Bulletin No. 2003-06

V6 and V8 GMEFI with No Start, Engine Miss-Fire or Engine Shut-off Conditions

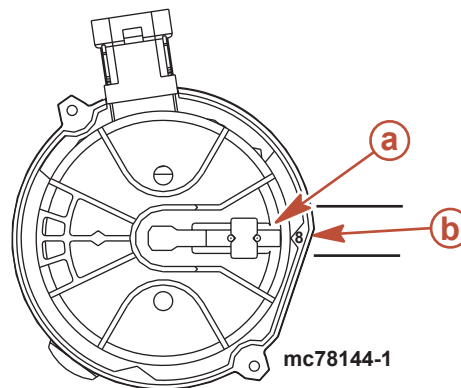
- MCM V6 and V8 MPI Alpha engines only: If you have an Alpha engine with an engine miss-fire or if the engine shuts off above 1200 rpm, the problem may be caused by the shift interrupt switch. To determine if the interrupt switch is the cause, disconnect the switch from the engine wiring harness. Use a small jumper wire to go between the A and C terminals in the engine harness connector.

- a** - Shift interrupt switch
- b** - Engine harness connection
- c** - Jumper wire between A and C terminals

If the jumper wire corrects the engine running condition, a new ECM with the latest calibration should be installed. Alpha engines built above the S/N below have the new ECM 555. If an ECM is needed, order the correct one listed below.

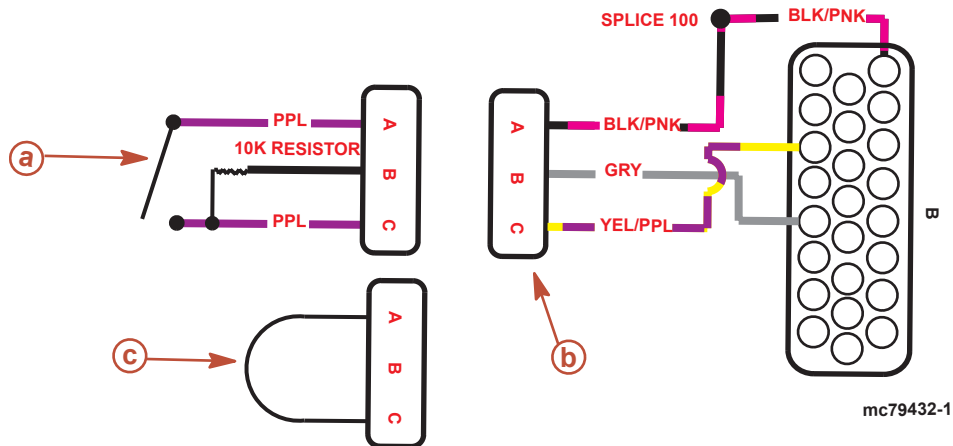
2. V8 engines only: If the performance of 1a and 1b (above) does not resolve the problem, bring the engine to TDC (firing). Remove the HVS distributor cap and verify that the rotor is pointing at the correct timing mark, 8, on the HVS housing between the 2 lines shown below. If this is correct, reinstall the HVS cap. Mark a reference line on the HVS distributor and intake manifold (so you know where the distributor was located after you move it in the following step). Loosen the distributor's clamping screw and rotate the distributor 1-2 degrees clockwise (viewed from top), then retighten the distributor's clamping screw. The engine should now run well. If it does not, then you can return it back to the original line that you marked before.

a - Rotor tang

b - "8" on housing
